**A RESOLUTION TO AWARD A CONSTRUCTION CONTRACT
FOR THE INTERSTATE 65 SEWER LINE CROSSING**

**RE: CITY OF SPRING HILL, TENNESSEE
I-65 SEWER LINE CROSSING
BIDS REVIEW AND RECOMMENDATION**

Re: Value Engineering: 30 inch SDR 26 IPS HDPE in lieu of 30 inch C-905 Fusible
PVC Carrier Pipe
Interstate I-65 Sewer Line Crossing
Springhill, TN

**EXHIBIT - GRAVITY SEWER EXTENSION UNDER INTERSTATE 65
 SPRING HILL, MAURY COUNTY, TN**

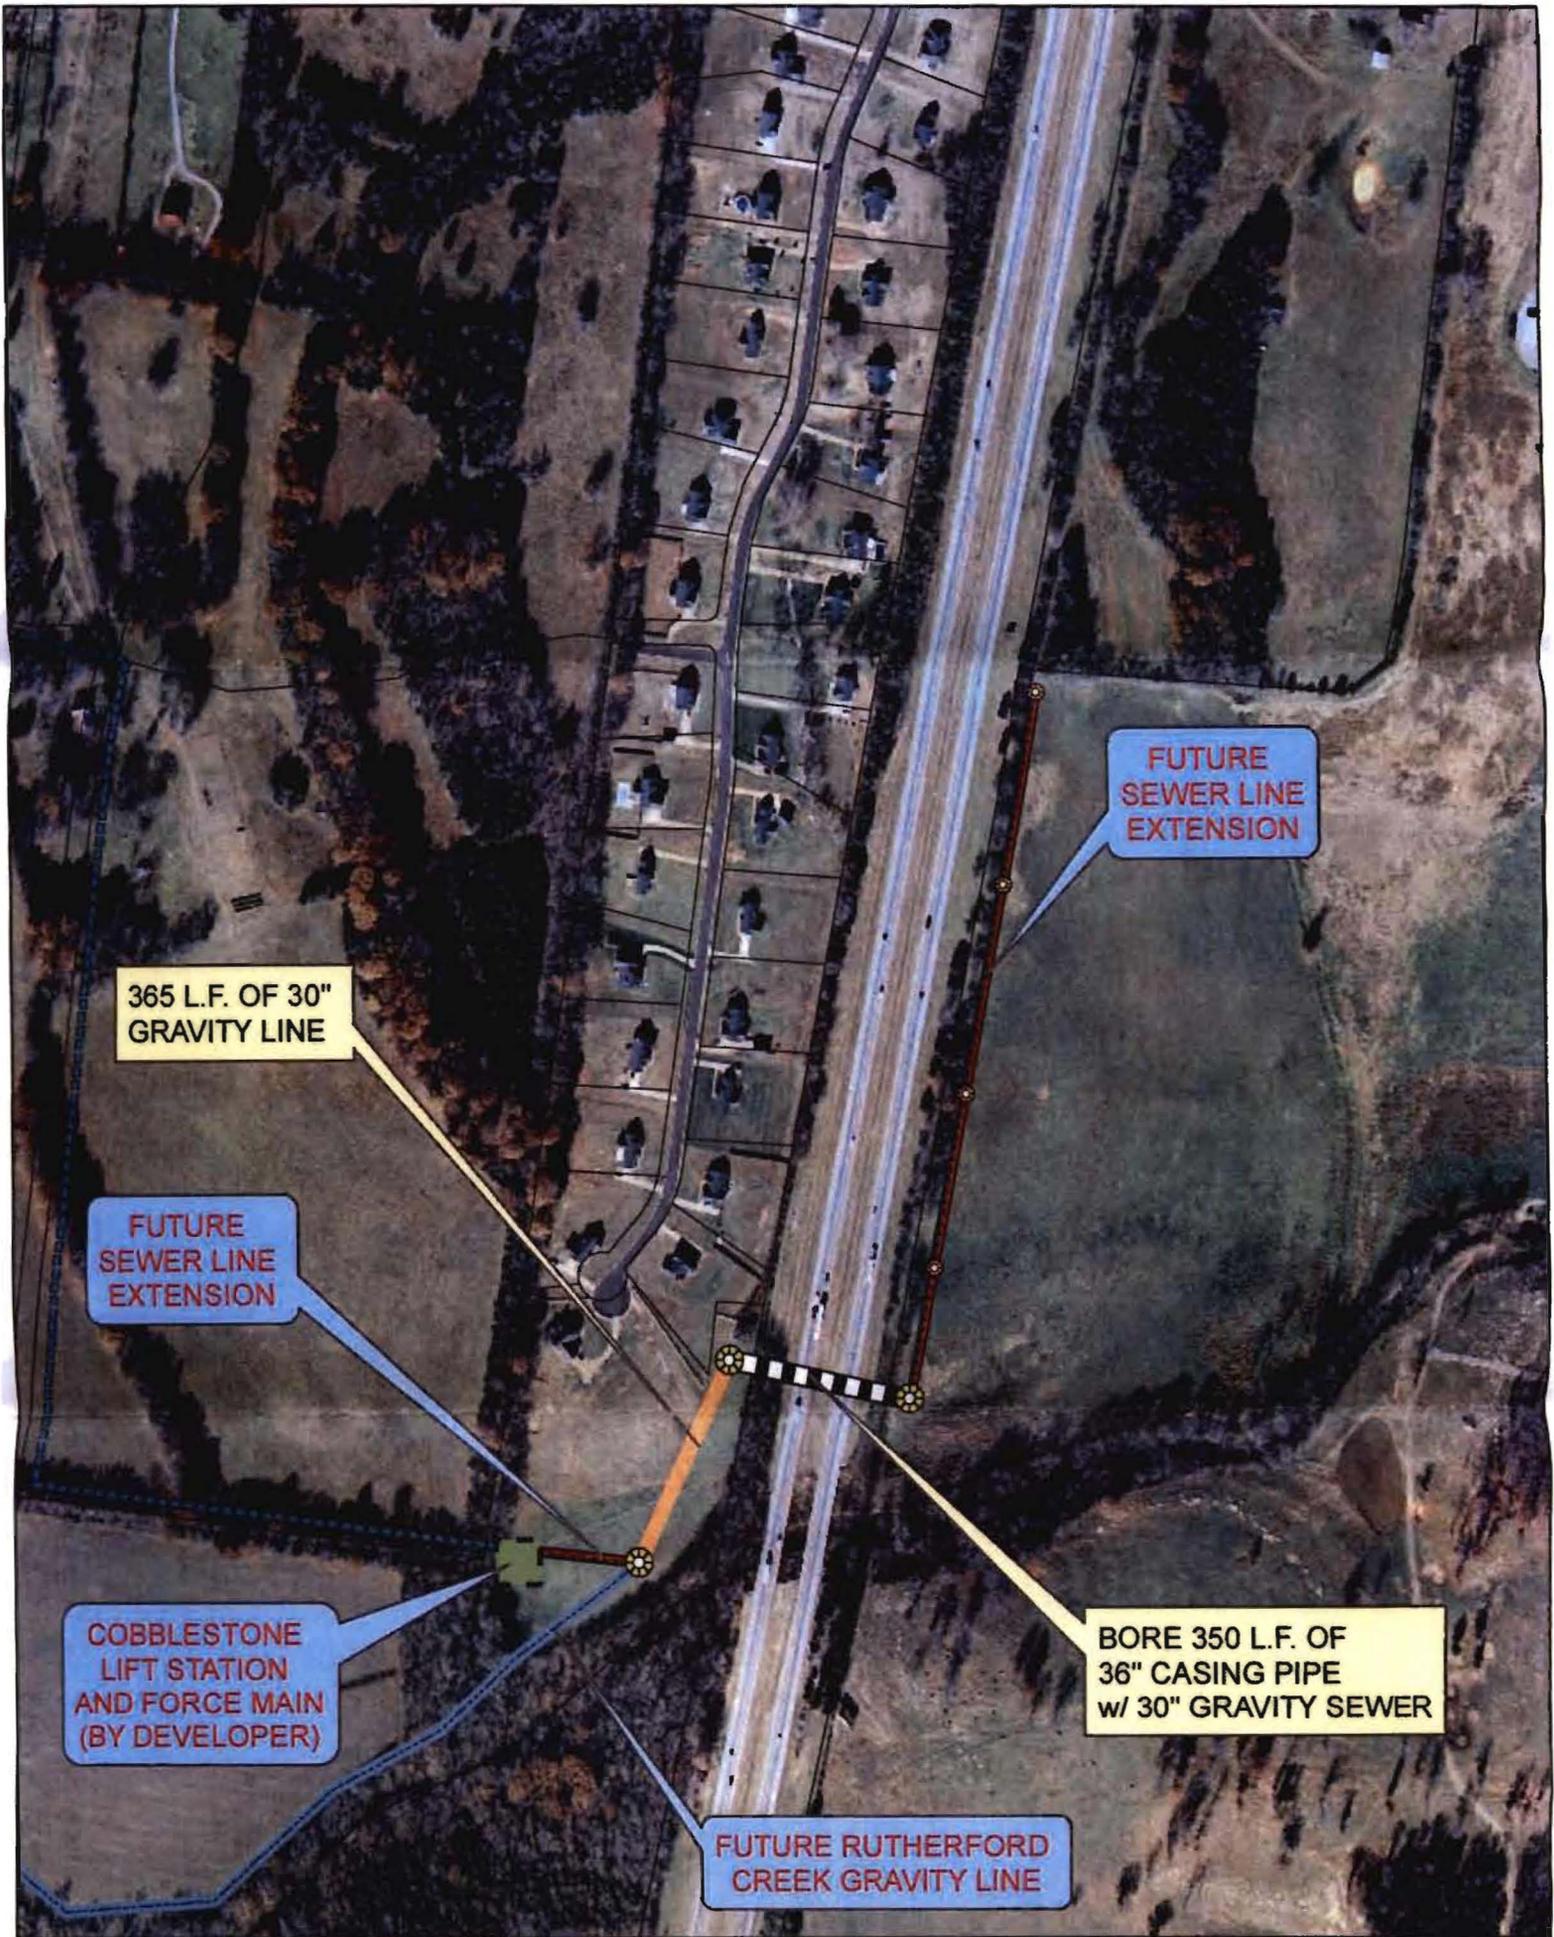
As discussed and requested, CFW, Inc. hereby respectfully submits the following unit price revision for material substitutions on the above referenced project.

Item 3A: Deduct \$80.00 per LF
Item 3 B: Deduct \$80.00 per LF
Item 5: Deduct \$80.00 per LF
